Public Service
Electric and Gas
Company

CONTROL ROOM HABITABILITY
HOPE CREEK GENERATING STATION
DOCKET NO. 50-354

ITEM 1. NRC TELECON - CONTROL ROOM HABITABILITY, OCTOBER 30, 1985

CONTROL ROOM HEAT-UP CURVE
(ASSUMING NO OPERATOR ACTION TAKEN)

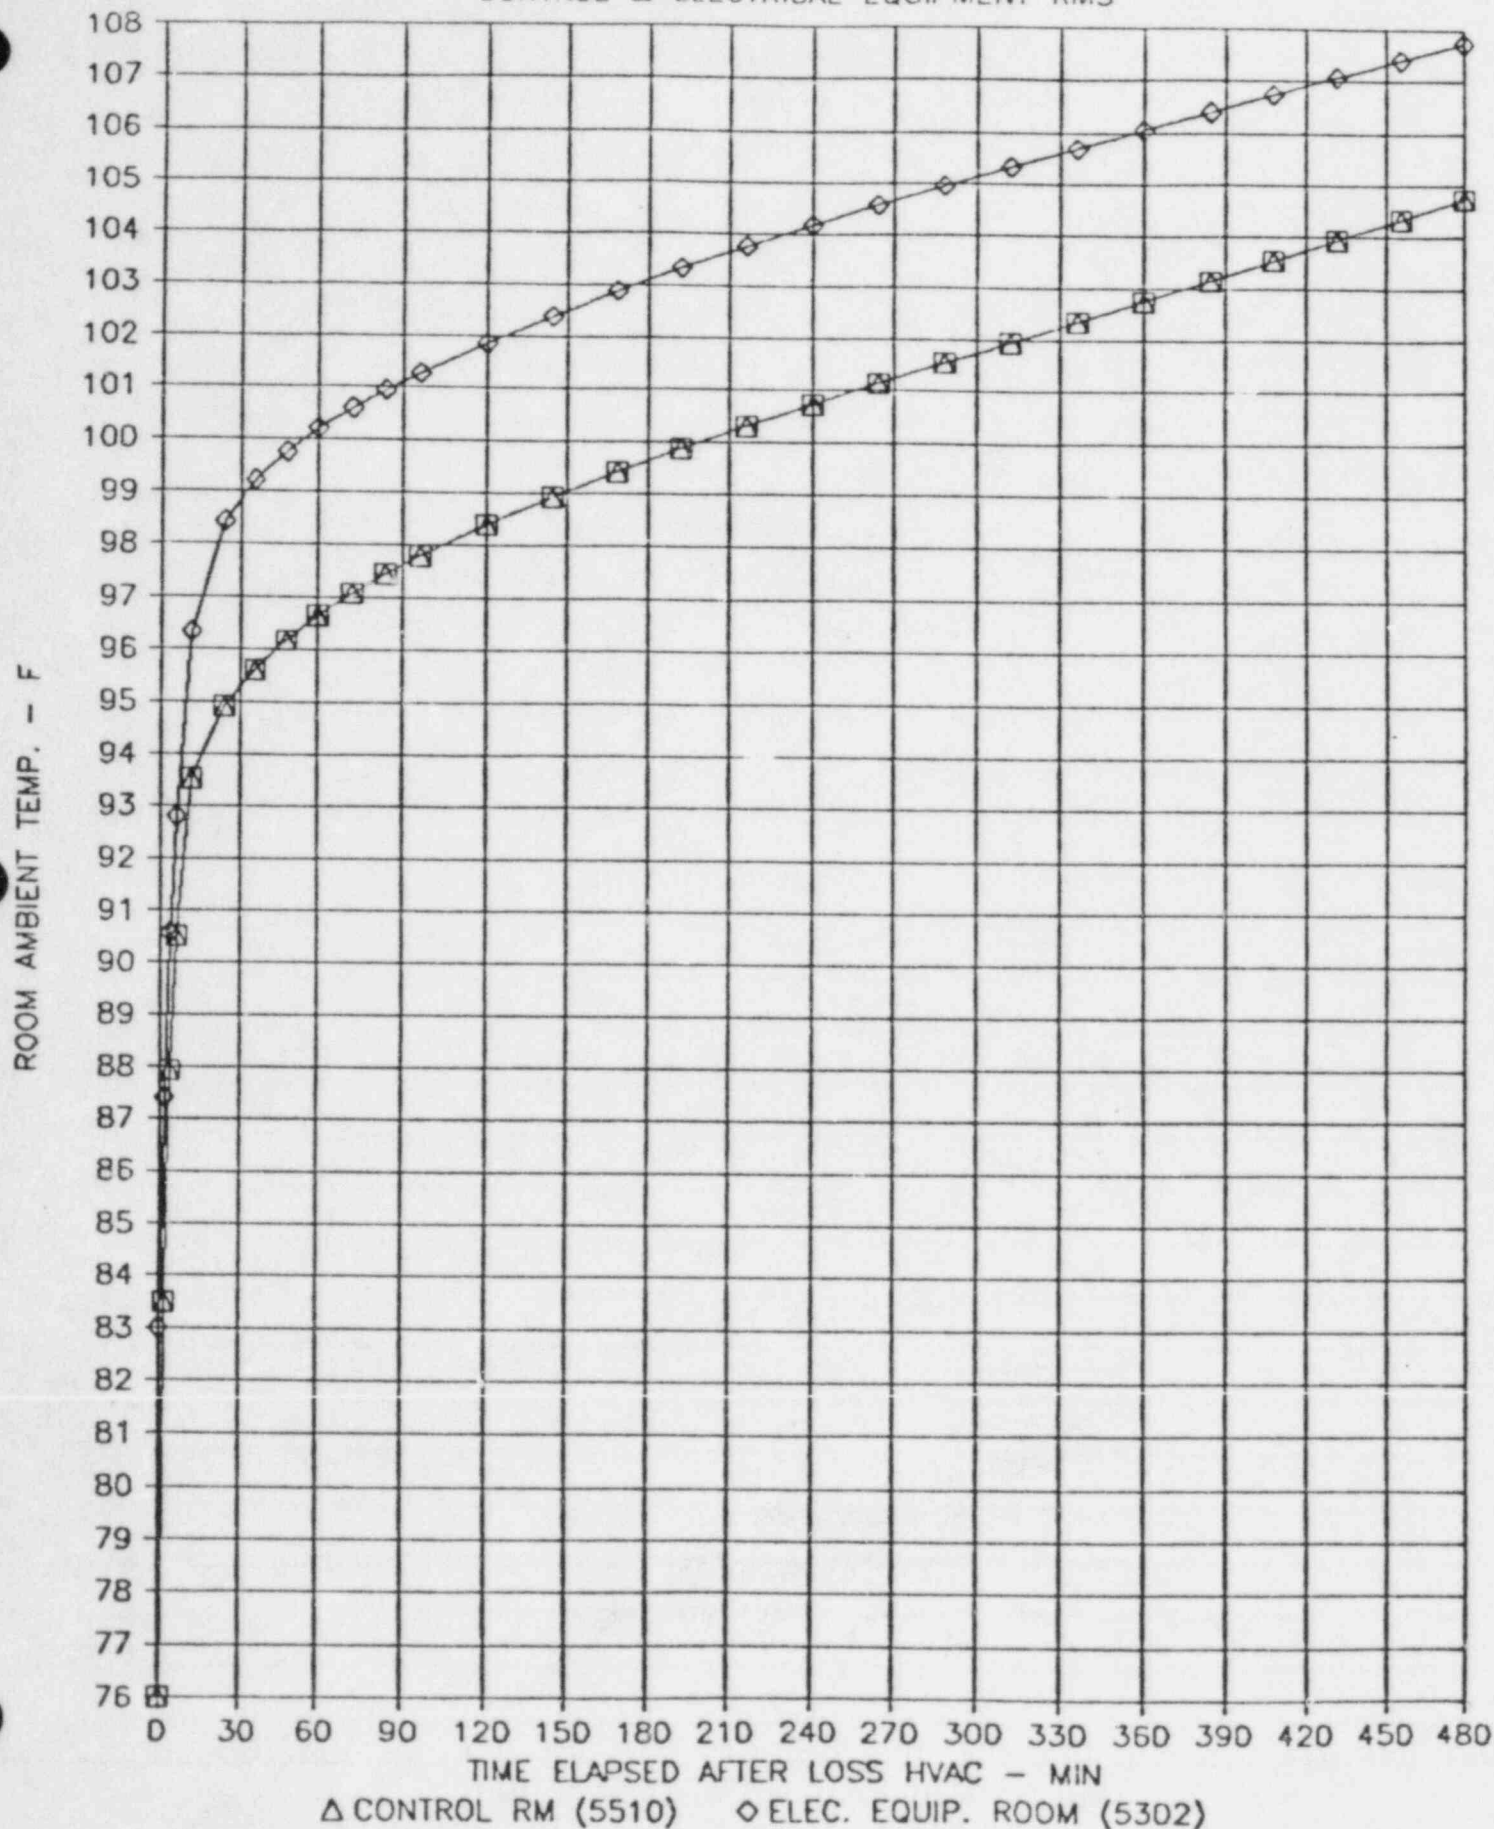
NRC CONCERN: "Provide additional temperature rise curves for inside cabinets and panels, indicating delta T between ambient control room temperature and temperature inside cabinets and panels; indicate all assumptions used in developing the curves."

NRC CONCERN: "Verify that control room ventilation system is of sufficient capacity that when the ventilation system comes back on-line it will immediately begin to remove the heat built up and prevent any further temperature rise (i.e., must demonstrate that qualification temperature values are not exceeded due to the duration between the time ventilation is restored and the point where heat input is effectively removed)."

Heat-up values for inside cabinets and panels is determined by adding the panel average temperature rise to the attached control room heat-up curve.

The control room ventilation system has sufficient capacity to prevent further temperature rise in the control room after it is restored. As seen from the attached control room heatup curve, the control room temperature six hours after loss of ventilation cooling is 102.8°F and the ambient air temperature rise gradient between six and eight hours after loss of ventilation cooling is about one degree F per hour. Within 15 minutes after the system is restored to full capacity, the control room ambient air temperature will fall to approximately 87°F. The air temperature will slowly drop to 76°F as the system removes the normal heat load plus the stored heat resulting from the room heatup event. Within 24 hours, the ventilation system will remove all stored heat and the control room conditions will be returned to normal.

SAMPLE
DATA
COLLECTION
SHEET

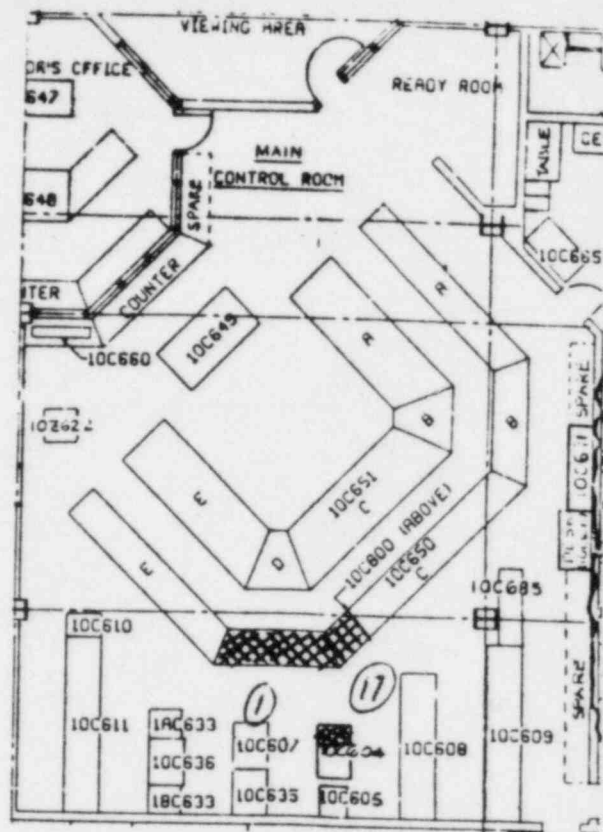
NRC CONCERN: "Account for temperature rise inside the cabinets (local hot spots)."

The field temperature measurements provide indication of any local panel hot spots. Each panel was visually reviewed prior to placement of thermocouples to establish potential hot spots. Thermocouples were then placed within close proximity of any potential hot spots such as transformers, power supplies, heavy duty relays, CRTs, lights, etc. to generate worst case conditions. The attached Sample Data Collection Sheet is an example of thermocouple placement in a panel. The maximum panel temperature difference is 34.3°F in panel 10C651B where the temperature sensors were placed near a CRT and a light bulb. The average temperature for this panel is 27.8°F. This value is considered a conservative indication of panel hot spots.
